ADDENDUM NO. 1

**PROJECT NAME: 2016-2017 FLATWORK TASK ORDER CONTRACT PACKAGE 16
– 23-01429**

DATE: 9/15/2015

CONCRETE SIDEWALK SECTION

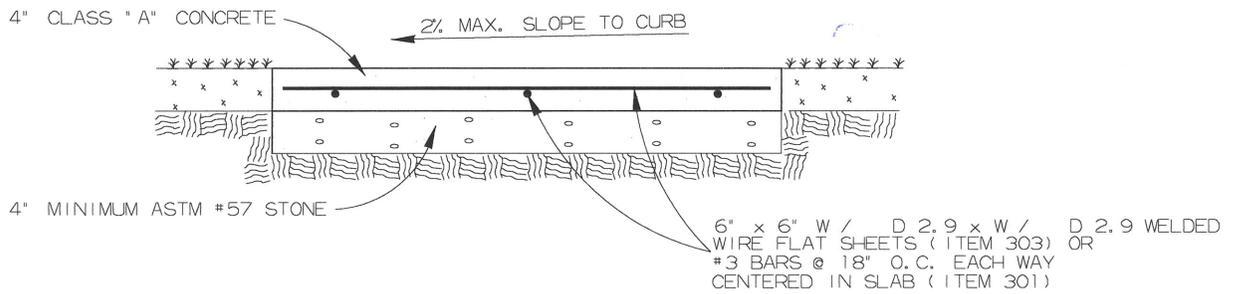
- a. SUP Spec 13 – ASTM 57 Stone for Concrete Sidewalks
- b. ASTM 57 Stone for Concrete Sidewalks Detail

THIS BASE SECTION SHALL BE USED IN LIEU OF FLEXIBLE BASE ON A CASE BY CASE BASIS AND AT THE DISCRETION OF THE ENGINEER OR PROJECT MANAGER. FOR PROJECTS THAT REQUIRE ASTM #57 STONE BASE, THE 2" FLEXIBLE BASE SECTION WILL BE OMITTED. PAYMENT FOR ASTM #57 STONE WILL BE PAID IN A SQUARE YARD BASIS UNDER THE CONTRACT BID ITEM.
